**0.0 PLANNER'S REPORT FOR PLAN CHANGE 93 – TE PUNA SPRINGS****File Number: A4524920****Author: Anna Price, Senior Consents Planner****Authoriser: Rachael Davie, General Manager Strategy and Community****INTRODUCTION**

1. The purpose of this report is to provide recommendations on submissions and further submissions to Plan Change 93 – Te Puna Springs.

Figure 2: Current Rural/Commercial Zone split across the site

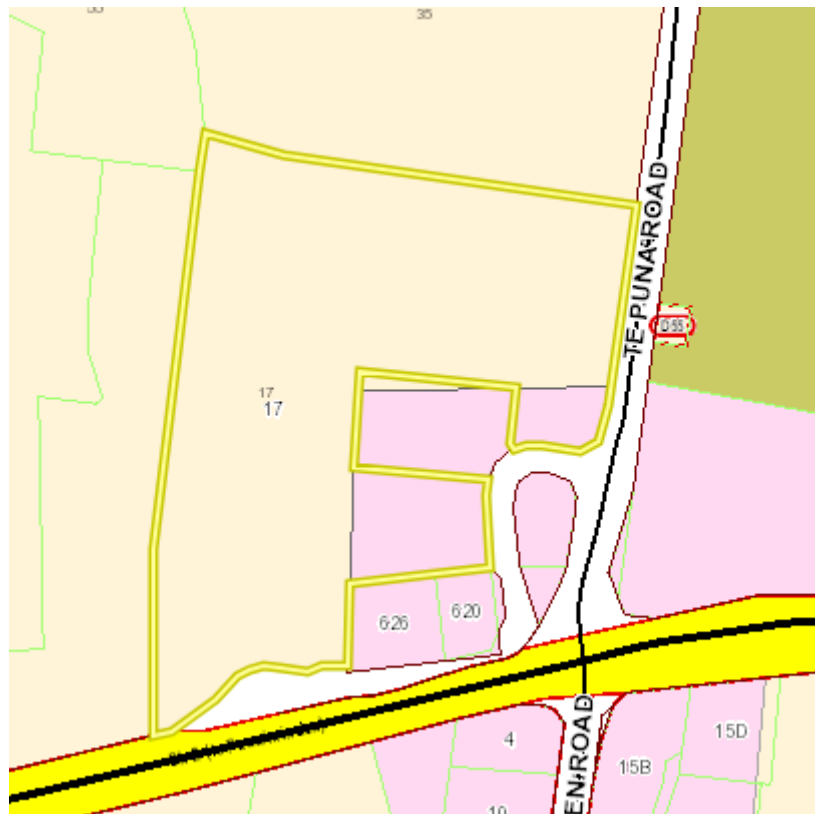
Submission 8.9 – Support the rezone to Commercial, however request further regard to the Te Puna Community Development Plan.

Figure 5: Flood modelling show on the subject site

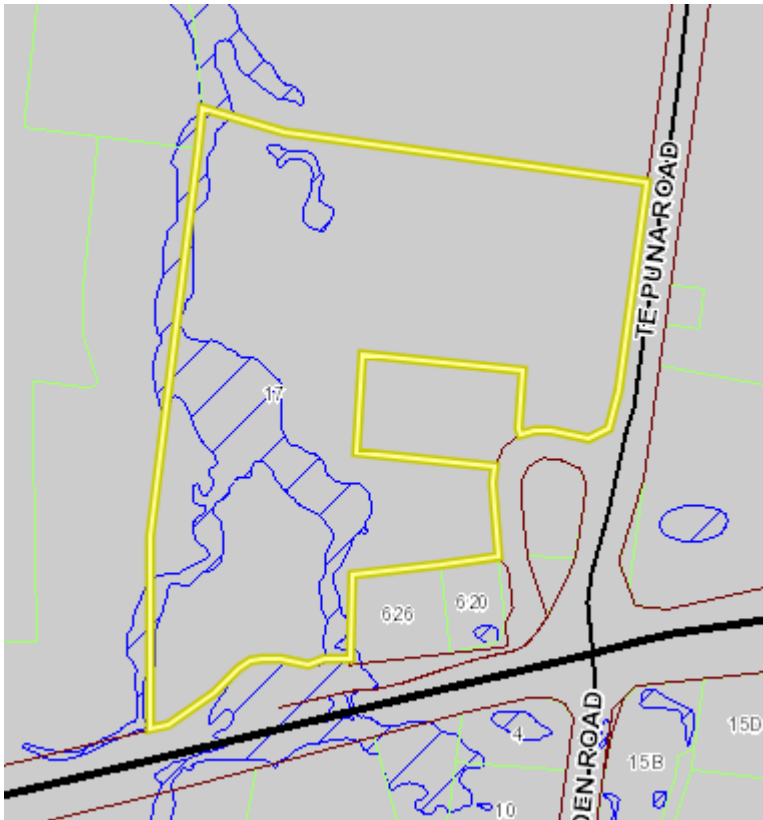
Submission 10.2 – Clause (a) of Policy NH9B of the Regional Policy Statement requires a Natural Hazard Risk Assessment be undertaken for changes in land on urban sites of more than 5ha. Requests a risk assessment for each natural hazard the site is susceptible to, prepared in accordance with Appendix L of the Bay of Plenty RPS. Full details of the background flood model and associated maps used to inform flood risk including clarification as to climate change scenarios. A feasibility assessment or similar reporting from a Suitably Qualified or Experienced Person to confirm that the proposal would be safe to evacuate people in 1% AEP flood event. Provisions to ensure a low level of risk can be achieved within the plan change area without increasing risk outside of the plan change area. Further provisions maybe required to achieve a low level of risk for other hazards to give effect to the natural hazard provisions, in particular Policy NH 4B (i.e. land instability building setbacks for landslide hazard).

Policy NH 9B sets out where a Risk Assessment is required. As the area to undergo change is less than 5ha, under part (b) WBOPDC can consider if a risk assessment is appropriate having regard to clauses (b)i-iv.

Council holds flood maps<sup>1</sup> and levels (taking into account 100 years of climate change as required by the RPS) for the whole of the District. Our flood models include Waihi Beach, Katikati, Omokoroa, Te Puke, Wairoa River and Rural Areas and Small Settlements. As such Council no longer need to rely on the Regional Council for flood levels. The flood level for the site is confirmed to vary across the site from 17.85m R.L. to 11.47m R.L. The stormwater mitigation proposed by the applicant has been reviewed by Councils Utilities team who have confirmed that the proposed stormwater mitigation and site development the flood levels will be irrelevant to the site as stormwater is proposed to be adequately managed.
